**AIA**<sup>®</sup>**Document G701<sup>™</sup> – 2001****Change Order****PROJECT** *(Name and address):*

North Hardin High School Renovation

**CHANGE ORDER NUMBER:** 010**DATE:** July 20, 2017**OWNER:** ☒**ARCHITECT:** ☒**TO CONTRACTOR** *(Name and address):*Morel Construction Co.  
627 West Main Street  
Louisville, KY 40202**ARCHITECT'S PROJECT NUMBER:** 1291**CONTRACT DATE:** February 09, 2015**CONTRACT FOR:** General Construction**CONTRACTOR:** ☒**FIELD:** ☐**KENTUCKY DEPARTMENT OF  
EDUCATION:** ☒**THE CONTRACT IS CHANGED AS FOLLOWS:***(Include, where applicable, any undisputed amount attributable to previously executed Construction Change Directives)*

Adjust unsuitable soil allowance - (\$19,118.00)

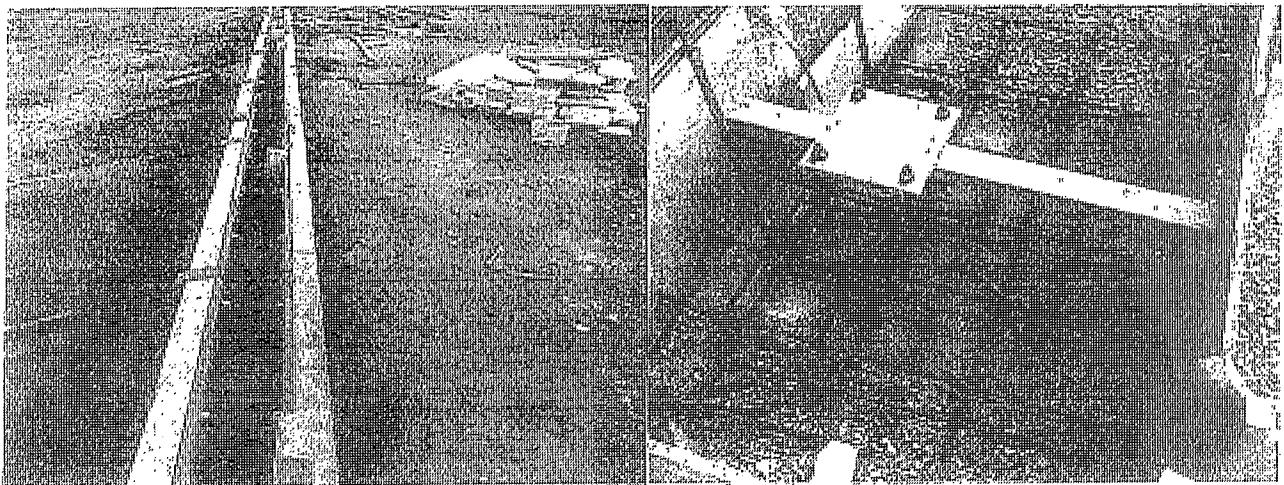
AEI was onsite as scheduled for inspections and testing. While onsite the following observations were made:

- Excavation of footings along existing south wall were being performed. Dynamic cone penetrometer testing was performed and yielded bearing capacities from 500 to 2000+ psf. Areas falling below the required 2000 psf bearing capacity were excavated and tested incrementally until adequate bearing capacities were reached. Two areas of over-excavation were needed and measured 11'x5'x2' and 9'x5.5'x2'. Excavations were backfilled with #57 stone.
- At 9:20 am, imi arrived onsite to deliver 10+ yd<sup>3</sup> of 4000 psi concrete. Reinforcing steel was inspected prior to pour and found to be in general accordance with drawing details and specifications. Bars were appropriately sized, spaced, and lapped. Reinforcement in footings were elevated on concrete chairs.

$$11 \times 5 \times 2 = 110 \text{ cf}$$

$$9 \times 5.5 \times 2 = 99 \text{ cf}$$

$$\underline{209 \text{ cf}}$$

$$\underline{7.74 \text{ cy}}$$

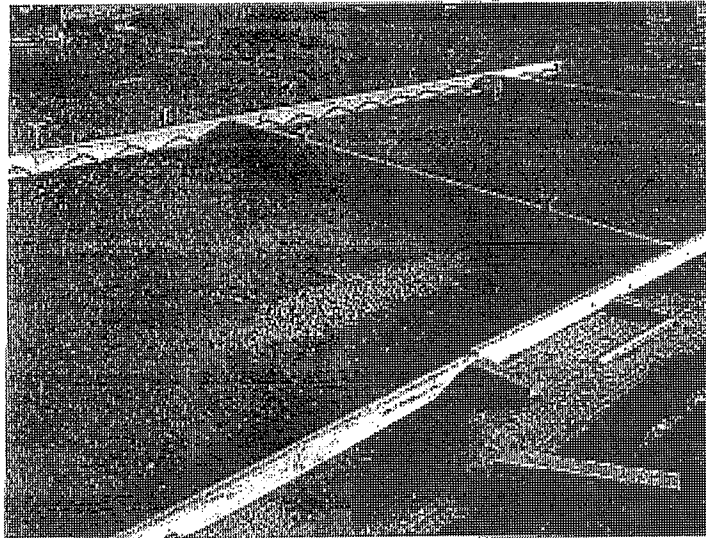
AEI was onsite as scheduled for concrete pour of sidewalks on north and south edge of area east of the field house. While onsite the following observations were made:

- Upon arrival, the area to be poured was inspected. Rain from previous day had caused upper crust of DGA to be wet, however walking the area, subgrade seemed firm and no water was standing in the forms. Hole that had opened from utility trench settlement observed on previous day was filled with #57 stone.

2000 psf bearing capacity requirement was identified and undercut to an acceptable bearing material. Area of undercut measured 12 foot by 2 foot by 1.5 foot. After undercutting was finished, footing was backfilled with #57 stone.

$$12 \times 2 \times 1.5 = 36 \text{ cf.}$$

1.33 cy

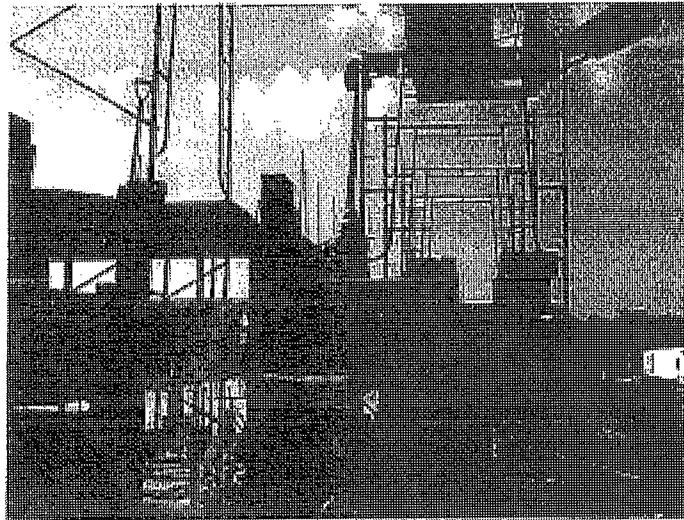
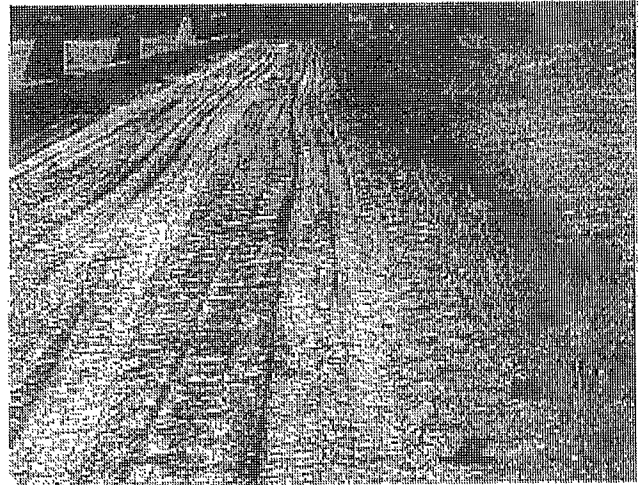
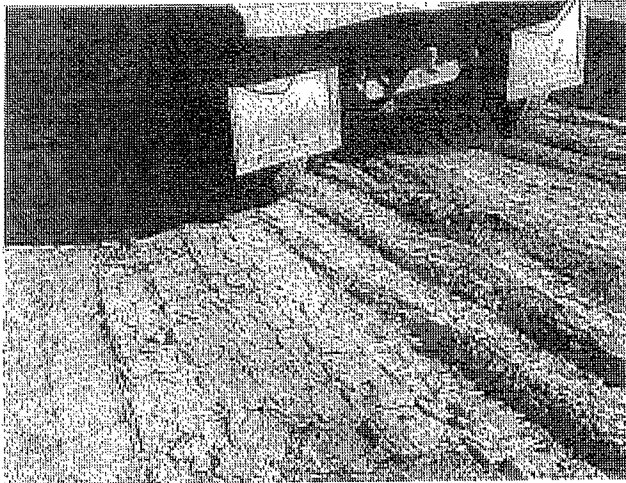
AEI was onsite for inspection and testing of subgrade for parking lot sections to receive brick pavers. While onsite the following observations were made:

- The southern 300 feet of parking area to receive brick pavers had been cut to subgrade. A proofroll was performed using a fully loaded triaxle dump truck. Rutting and pumping of 2 inches or more was prevalent in several areas. After discussion with Dennis Mitchell, PE of AEI who conferred with Ben Sorrell, SCB, it was determined that the area in question should be graded and smooth drum rolled. The following modifications were made to the subbase design:

1. 4 inch lift of DGA in bottom of base was to be eliminated.
2. Geotextile fabric is to be placed at subgrade. Placement is to follow per detail.
3. #2 or #57 stone is to be placed in bottom 4 inches instead of DGA.
4. The remainder of the design is to be placed as specified in drawings and specifications.

10.25 cy

- A sample of #2 stone to be used for fill was taken and returned to AEI for review.
- Also while onsite, concrete contractor was excavating footings at southern end of area A addition. These footings were tested via dynamic cone penetrometer. At initial bottom of footing grade, bearing capacities ranged from 250 psf to 1250 psf. Undercutting was performed per previous recommendations. Bearing capacities were tested in one foot increments until suitable bearing capacities were achieved. Undercut areas were backfilled with #57 stone. Total amount of material removed measured 10.25 yd<sup>3</sup>.

Blocking and bricking of 3 louvers.

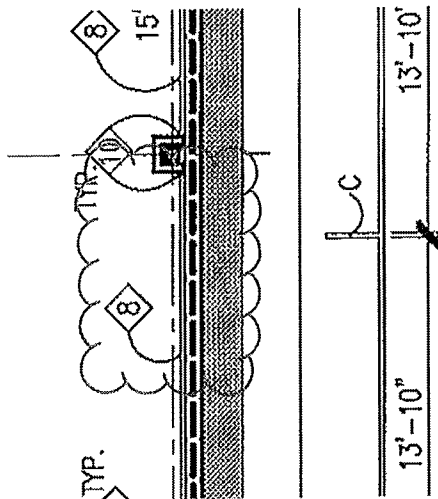
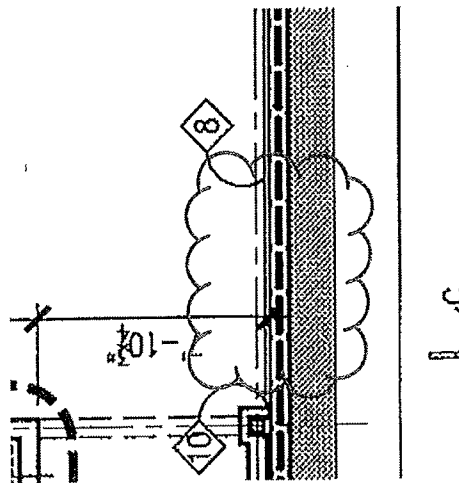
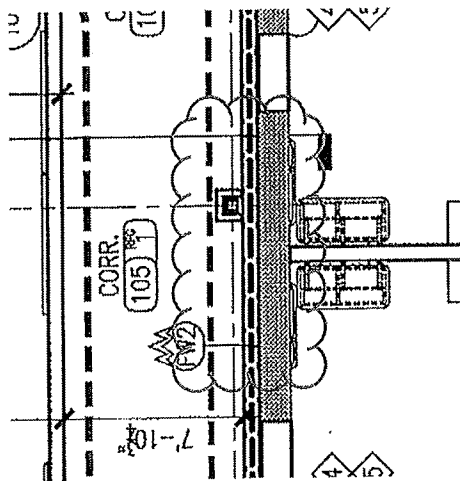
ITEM	QUANTITY	MAN HOURS	PRICE PER		TAX	TOTAL
			UNIT	UNIT		
MASON	1	16	\$	25.37		\$ 405.92
SKILLED LABOR	1	16	\$	21.83		\$ 349.28
CMU	120		\$	1.25	\$ 9.00	\$ 159.00
MORTAR	1		\$	125.00	\$ 7.50	\$ 132.50
GROUT	1		\$	125.00	\$ 7.50	\$ 132.50
BRICK	600		\$	0.65	\$ 23.40	\$ 413.40
OH&P	1					\$ 159.26
						\$ 1,751.86
